Te Hui o Te Kaunihera ā-Rohe o Heretaunga
Hastings District Council
Hearings Committee Meeting

(Oderings Nurseries CHCH Limited - 55 and 57 Brookvale Road, H Nth)

2. ORDERINGS NURSERIES CHCH LIMITED - RESOURCE CONSENT APPLICATION FOR RESIDENTIAL DEVELOPMENT OF 55 AND 57 BROOKVALE ROAD, HAVELOCK NORTH (RMA20230145)

File Note: Alina Enovan, Development Engineer Consents
Date: 26 February 2024
Subject: RMA20230145 – 55 Brookvale Rd (Oderings) – engineering comments

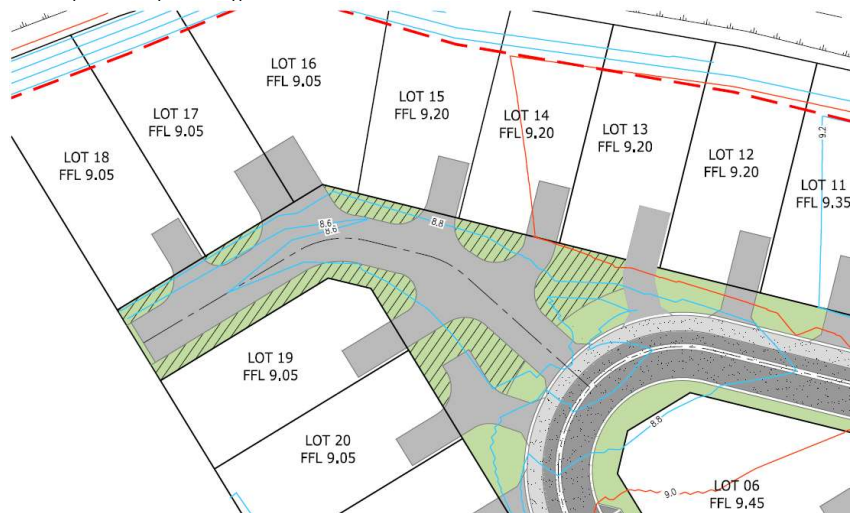
4. The flooding analysis done by the consultant is (100yr + CC) is lower than the HBRC flooding shown on the Hazards Portal map (50yr no CC). For comparison, the consultant states that the 100yr + CC flood is not overtopping the Karituwhenua Stream banks, while the HBRC map shows flooding over the lower part of the section.

Using the HBRC flood level this would indicate some flooding in the lower reaches of the ROW (Lot 102 (Access)). ROW sits around RL 8.6:

From the above, it would be necessary to understand.

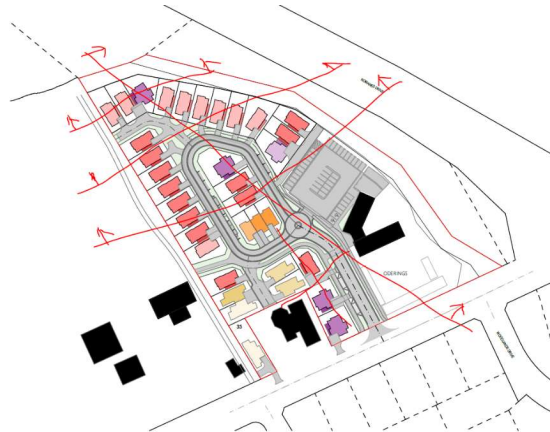
11. Please confirm whether the intention is for the wastewater pump station to be vested or kept as private infrastructure. If the pump station is to be vested to Council, the developer will need to vest the land on which it sits, at no cost to HDC. Please amend the Scheme Plan accordingly.

The wastewater pump station needs to be always accessible. Please demonstrate that HDC can maintain and access it.

Note: depending on whether the pump station is to be vested as public or private will determine how Council views the loop road (Lot 100 (Access)) being public or private.

11. We intend to vest the new pump station to HDC, as noted on sheet 403.
12. We have not shown retaining walls on the plans yet, we intend to do this at detailed design stage. We anticipate that any/all walls will be under 1.5m and will not require BCs. The 6m separation is adhered to, and we intend to batter down to existing ground without retaining for the lots along the stream.
